Indoor Station Firmware V2.2.2_build221223

Release Note (2022-12-30)

Device Model	DS-KH8350-WTE1, DS-KH8350-TE1, DS-KH6320-WTE1, DS-KH6320Y-WTE2, DS-KH6320-WTE2(B), DS-KH6320-TE1, DS-KH8520-WTE1
Firmware Version	V2.2.2_build221223
iVMS-4200	V3.8.3.1 or later

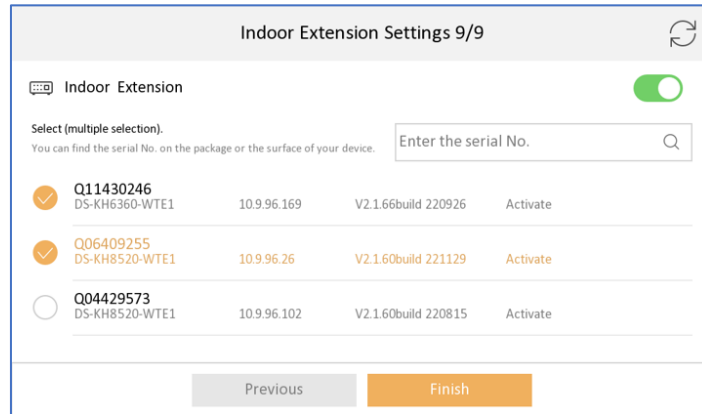
B. Link indoor station with main and sub door station

- the first selected will be the main door station by default, the second will be sub1, 3rd will be sub2, etc. You can also cancel and select the main door station manually.
- Maximum select 17 door stations at one time (1 main and 16 sub door stations)
- If the selected devices are not activated, indoor station will activate them with same activation and registration password, then set the IP address for them in same network segment automatically.
- If the door station is already activated with different password, it will prompt you to input door station password
- If the main and sub door station are activated with different activation password, the registration will be failed (sub door station can't call indoor station).

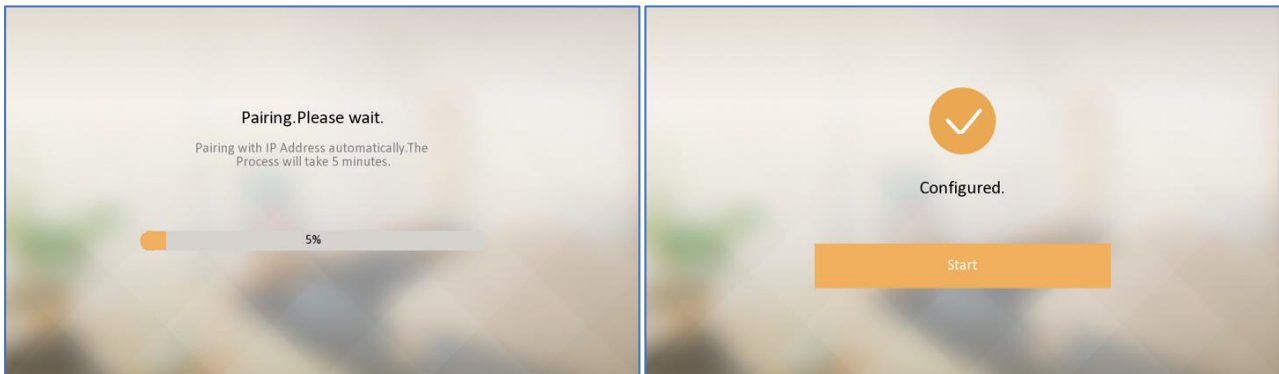
D. Pairing with main door station, sub door station and indoor extension

Note: The pairing time duration depends on the device quantity you selected in previous steps, it will take about up to 5 mins, please wait patiently until the process finish and show “Configured” as below.

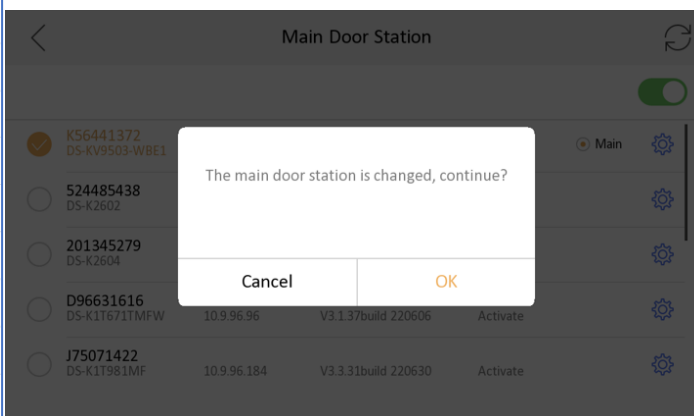
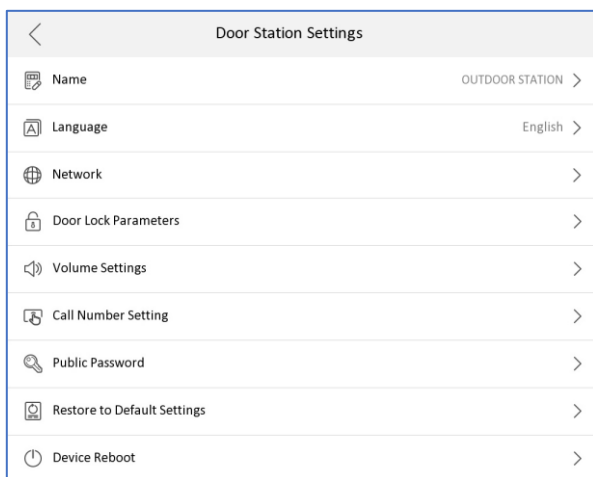
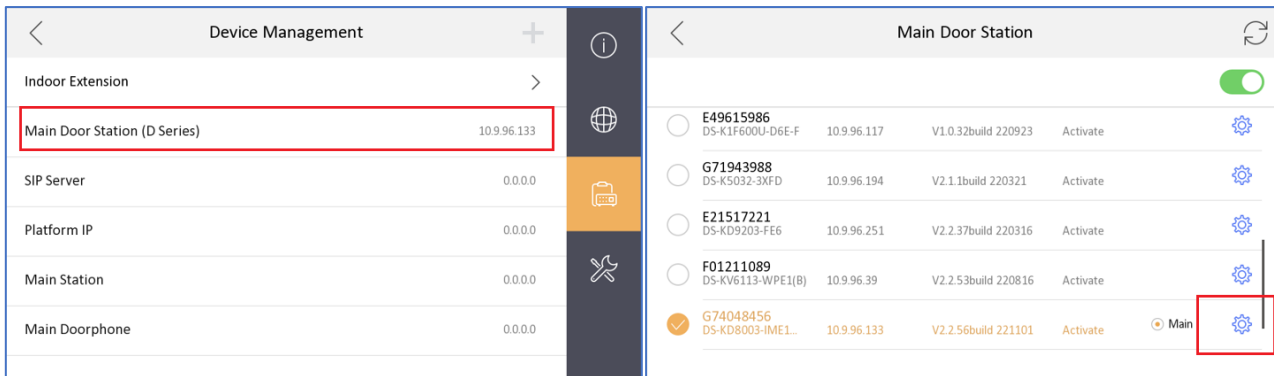
4. Set the important parameters of door station from indoor station Menu-Advanced settings-Configuration-Device Management-Main Door Station (not from the wizard).

- You can change parameters of all door station (no matter it's linked or not) in the list by click the setting icon, see pic 2.
- You can also change linked main door station from this list by click device from the list, if you want to change linked sub door station, please go to Advanced settings-Configuration-System maintenance-Wizard, and link device again.
- After change the linked main door station, device will prompt “The main door station is changed, continue?”, see pic4 as below

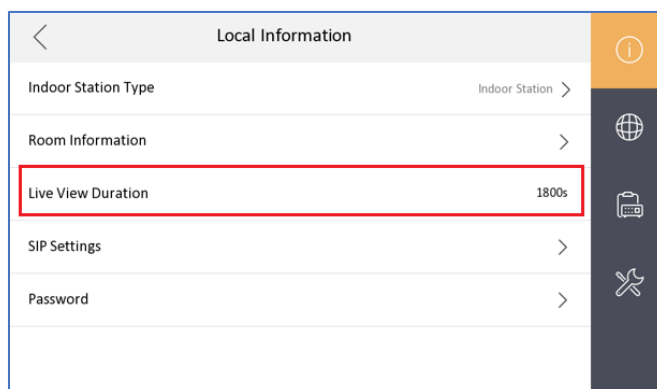
1. Optimized the icon of door station registration status in the main UI up right corner.

Note: If the door station call indoor station failed, you can click this icon  to register to door station manually, if register failed, it will indicate the reason for the failure.

Before	Now
Indoor station registers to door station success		
Indoor station registers to door station failed		
Indoor station registers to door station and KM9503 success

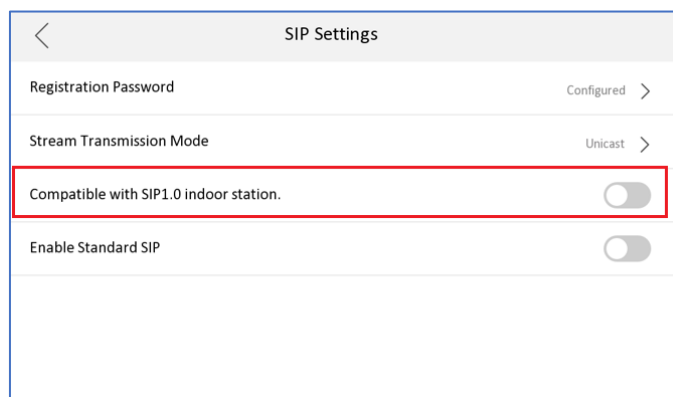
3. Support switching between protocol 1.0 and 2.0, by default it's protocol 2.0
After enable, the indoor station is compatible with protocol 1.0 indoor extension and not

compatible with protocol 2.0 indoor extension.

Note: After enable, all indoor extension of this indoor station must be protocol 1.0 firmware, don't mix protocol 1.0 and 2.0 indoor extension under same indoor station, or it will result to calling failed.

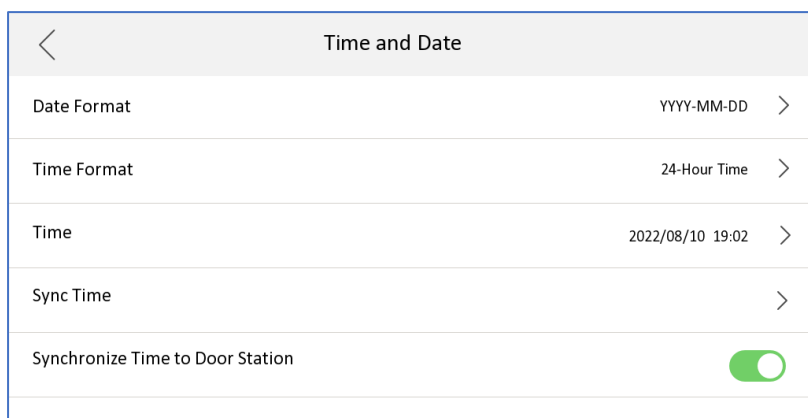
1. Supports static IP address configuration of Wi-Fi (DHCP, IP address, subnet mask, gateway, DNS1, DNS2).

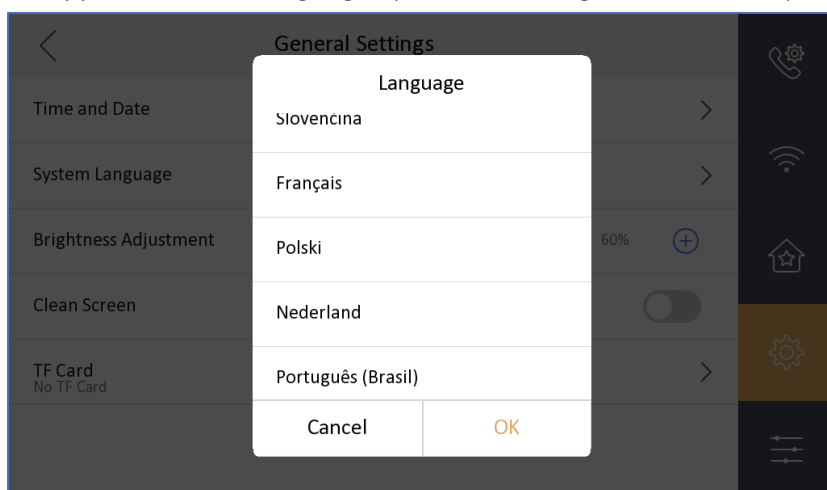
2. Supports configuring time and time zone for the door station.

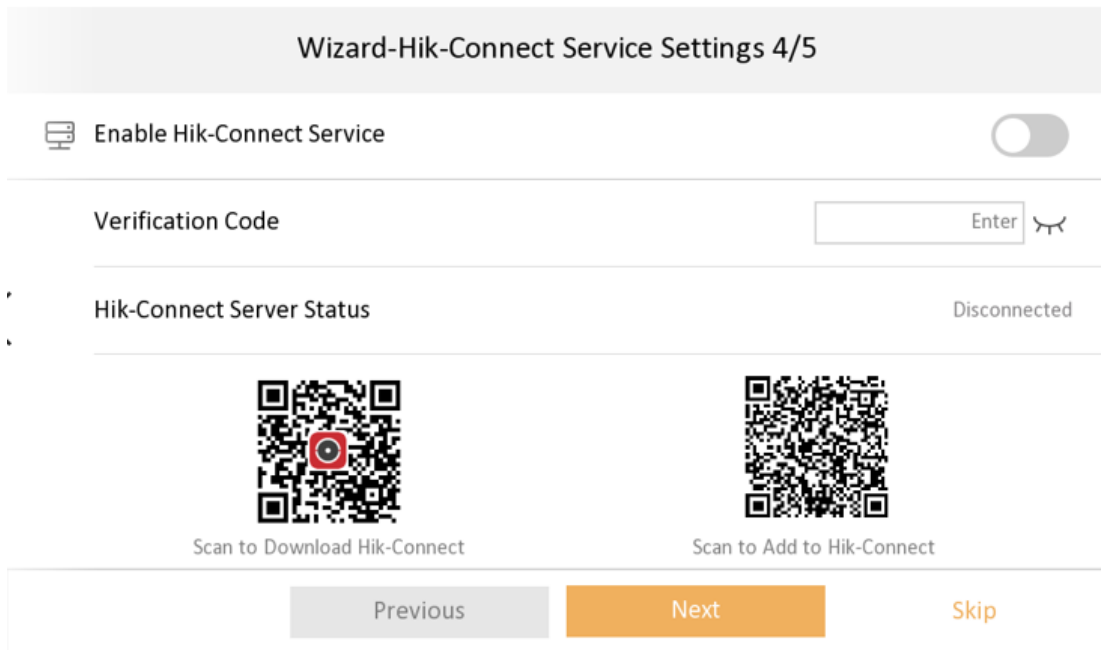
1. Optimize registration password settings in Wizard.

Be consistent with the activation password.
When enabled, the people who has the registration password will have the device admin permissions.

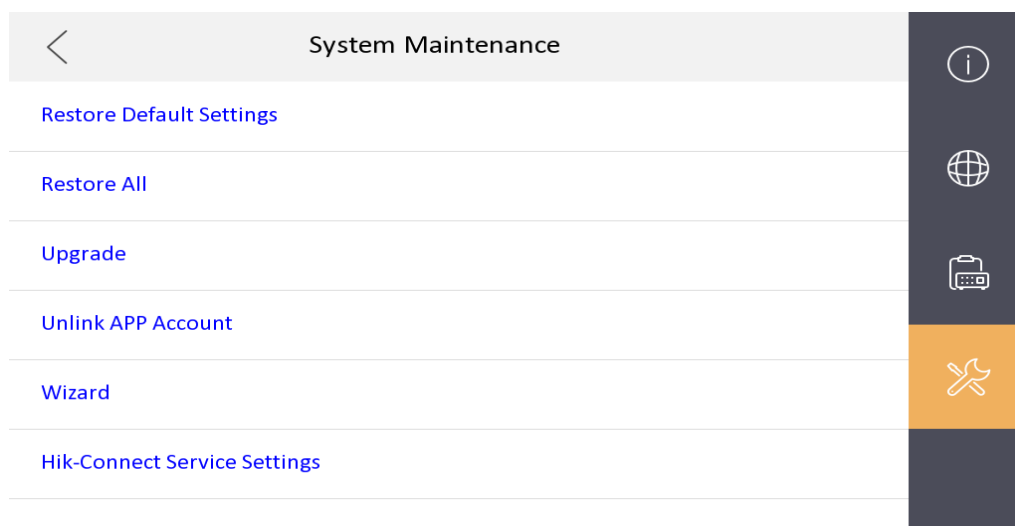
1. Verification code is empty by default.

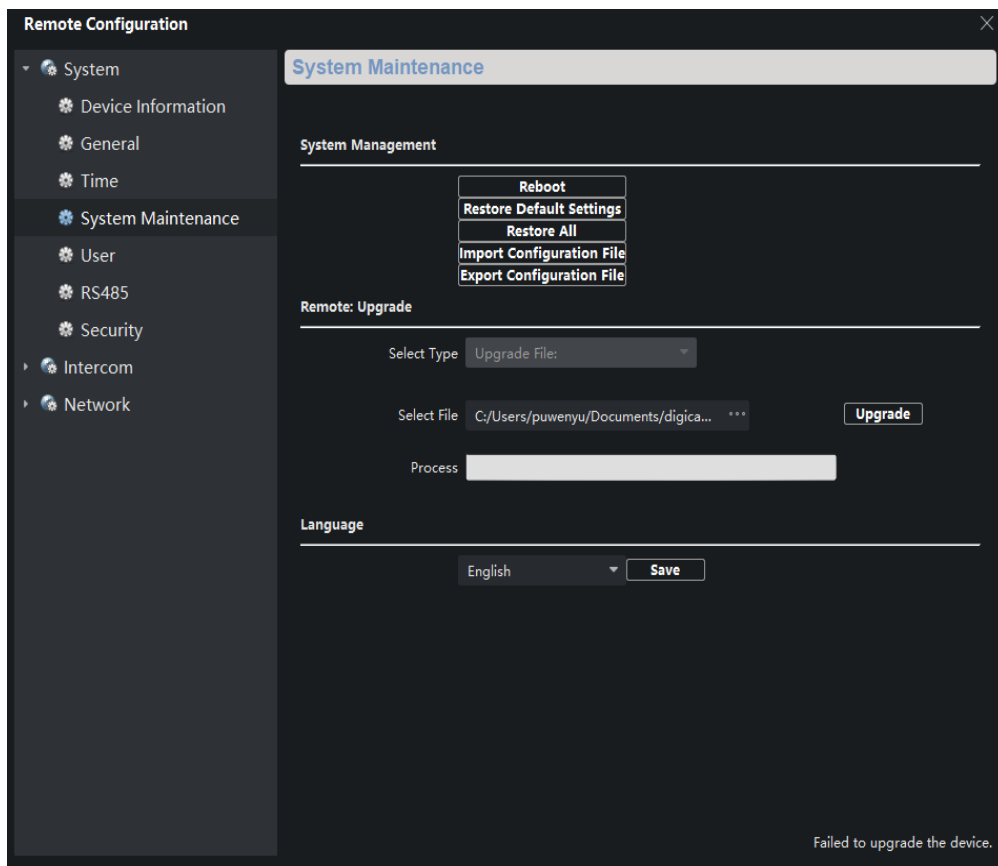
- Since **V2.1.24 build 210617**, remote

degradation of devices is not supported in all subsequent versions. When degradation occurs, it will prompt Failed to upgrade the device and the device will restart.

Notice: Although the device can be degraded by serial port, the device will fail to start and cannot change the version by using serial port again, which means that the device will be completely unusable.

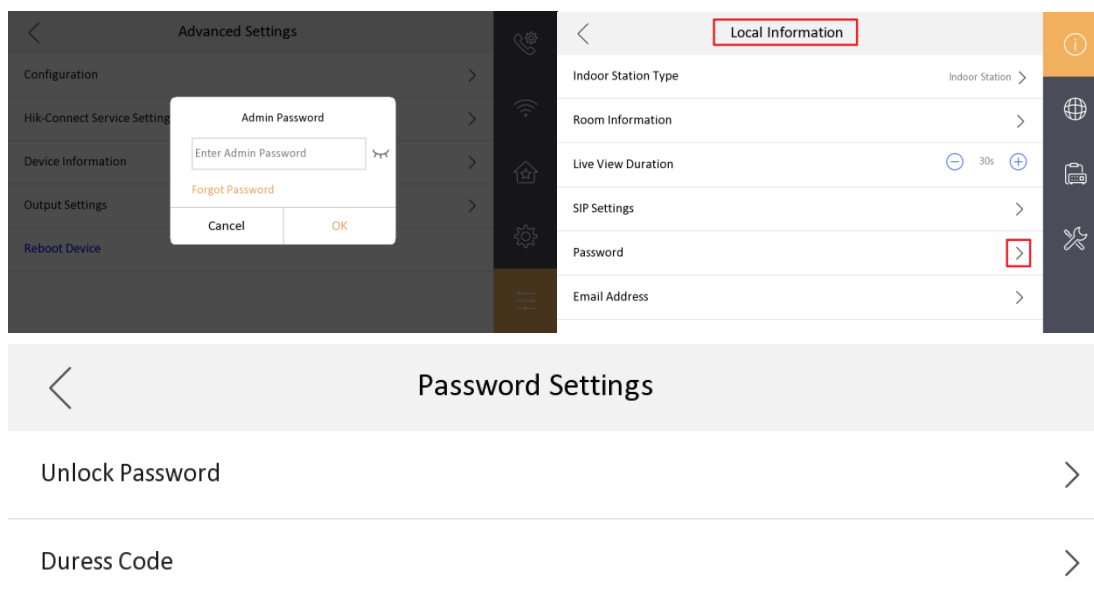
4. Add IPC interface, when Open Network Video Intercom protocol is selected, add plaintext ciphertext switch menu item configuration

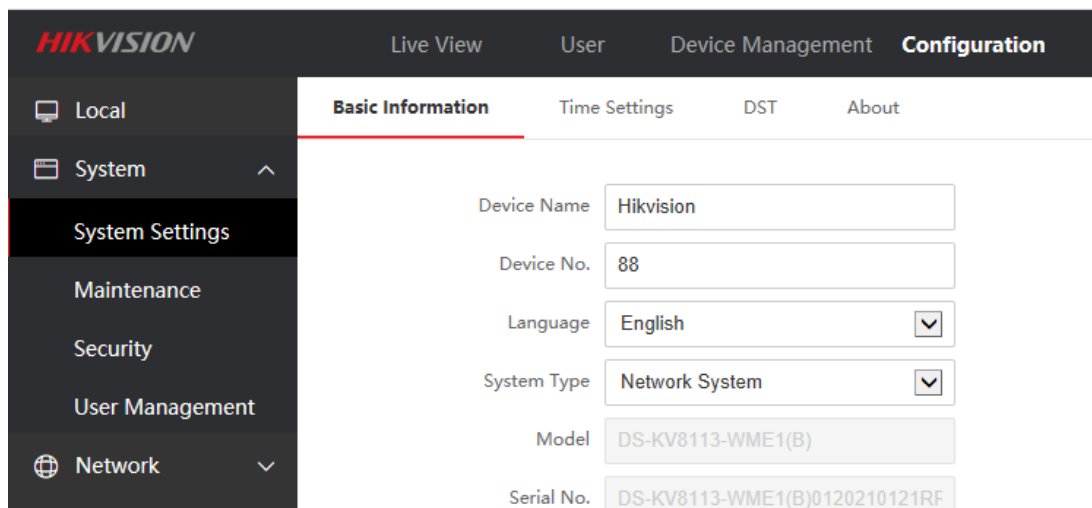
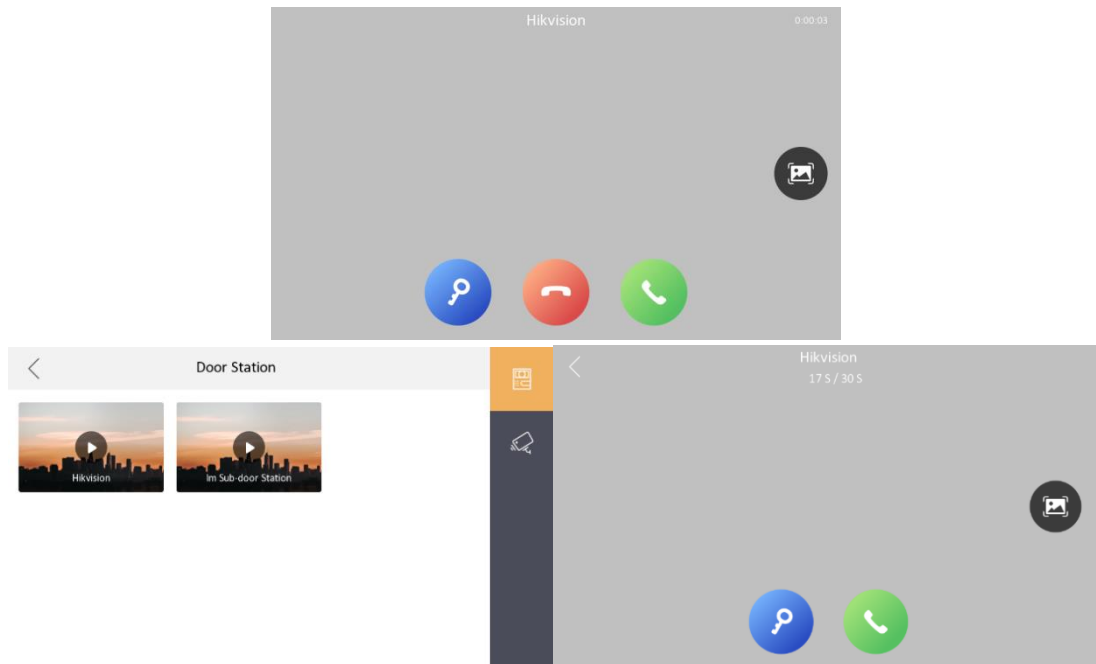
1. Change the position of unlock password and duress code, to enter the password page requires an admin (activation) password.
